Auto Spa Express

DSP-89016-06

STAFF REPORT

SUBJECT: Detailed Site Plan DSP-89016-06
Auto Spa Express

SITE PLAN

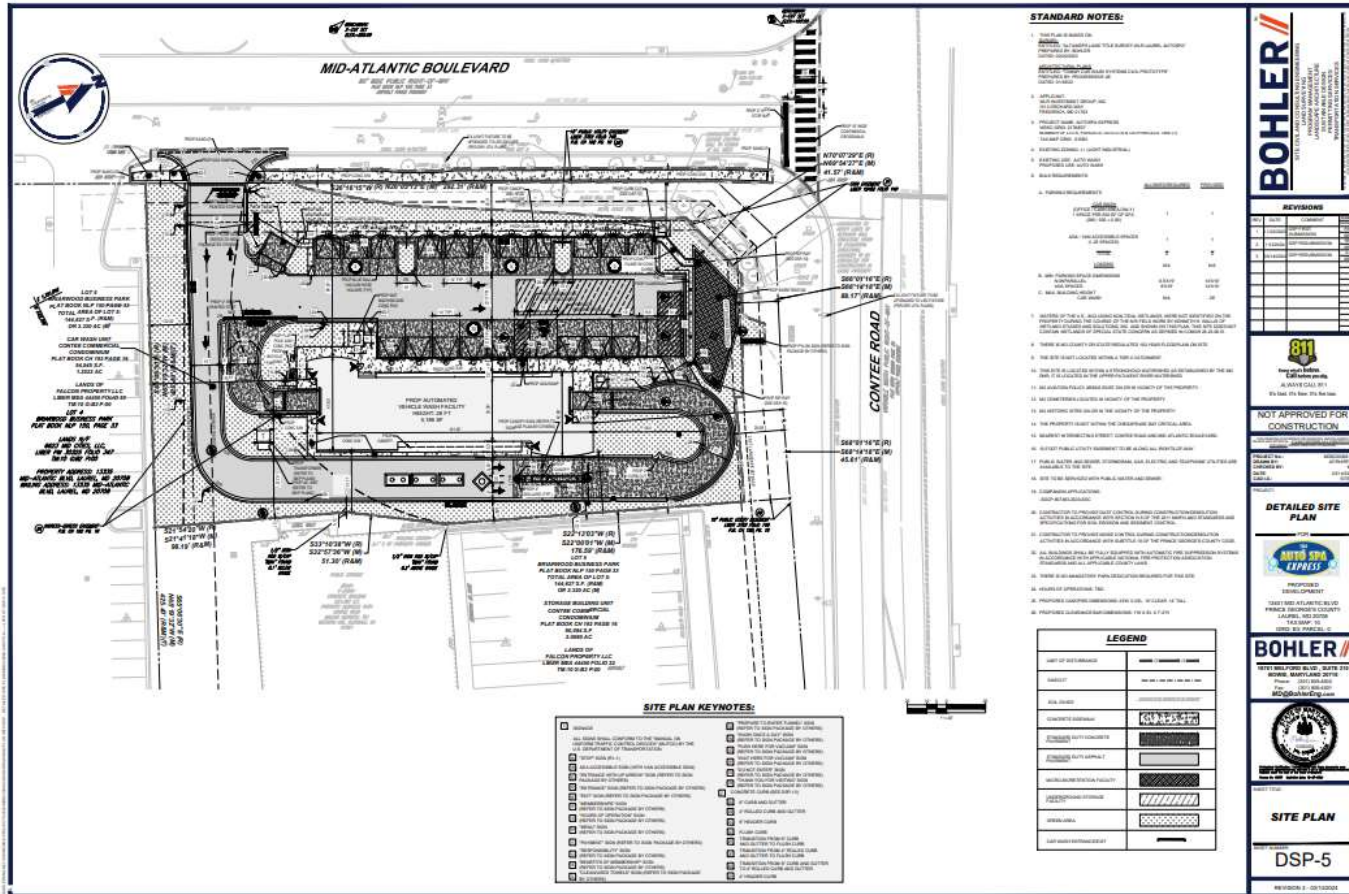
1. Prior to certificate approval of the detailed site plan, the following revisions shall be made, or information should be provided:
 - a. One freestanding sign shall be allowed. It must be located at the entrance to the subject site. The sign shall conform to the requirements of the prior Prince George's County Zoning Ordinance and the Briarwood Business Park Sign Covenants.

- b. Revise General Note 6 to indicate the correct proposed gross floor area.
 - c. Label the gross floor area of the proposed building on all plan views.

- d. Remove the numbered parking labels for the vacuum bays, as they are not parking spaces. Label parking spaces accordingly.
 - e. Revise Standard Note 6(B) to show the correct nonparallel parking space dimensions.

- g. On all plan sheets, extend the 10-foot-wide public utility easement (PUE) along the entire frontage of Contee Road, in accordance with the record plat. Correct the recording reference for the PUE to Plat Book NLP 150, Plat No. 33.

- h. Revise Survey Note 1 to identify the subject property as Lot 5, as recorded in Plat Book NLP 150, Plat No. 33.
 - i. Move the bearing and distance measurement of the southern property line for Lot 5 abutting Lot 4 to the outside of the property line, so it is not confused as an inside measurement for the condominium lot.

LANDSCAPE PLAN

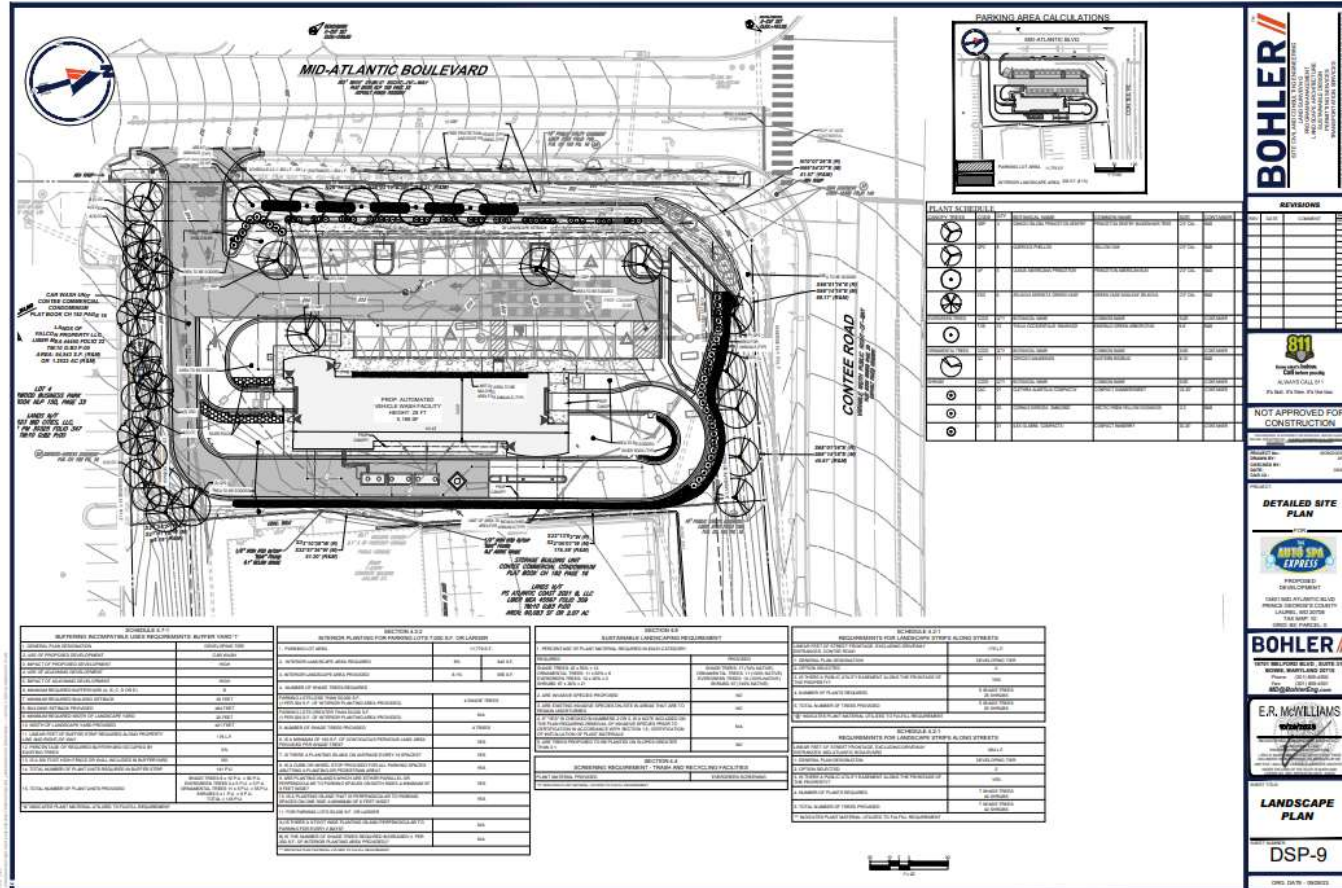
- a. **Section 4.2, Requirements for Landscape Strips Along Streets**—The applicant is using Option 2 to fulfill the requirements. Option 2 requires a minimum 10-foot-wide landscape strip and has an average width of at least 15 feet wide. Plantings are provided at a rate of one shade tree and five shrubs per 35 linear feet of frontage.

- b. **Section 4.3, Parking Lot Requirements**—Section 4.3 requires a percentage of the parking lot, determined by the size, to be planting area. In this DSP, the parking lot area is approximately 11,779 square feet. Table 4.3-1, Parking Lot Interior Planting Requirements, of the Landscape Manual, requires eight percent of the interior planting area, which is approximately 942 square feet. Schedule 4.3-2 on the landscape plans show 955 square feet of the interior planting area is provided.

- d. **Section 4.7, Buffering Incompatible Uses**—Section 4.7 of the Landscape Manual requires the buffering of incompatible uses. A car wash is considered a high-impact use. The adjacent commercial and professional offices are considered a medium-impact Use. As a result, a Type B bufferyard is required. The provided Schedule 4.7-1 on the landscape plans shows the application meets this requirement.

- e. **Section 4.9, Sustainable Landscaping**—Section 4.9 requires that a certain percentage of plants within each plant type (including shade trees, ornamental trees, evergreen trees, and shrubs) be native species (or the cultivars of native species). The minimum percentage of plants of each plant type required to be native species and/or cultivars is 50 percent for shade trees and ornamental trees, and 30 percent for evergreen trees and shrubs. The Schedule 4.9-1 provided on the landscape plans meets this requirement.
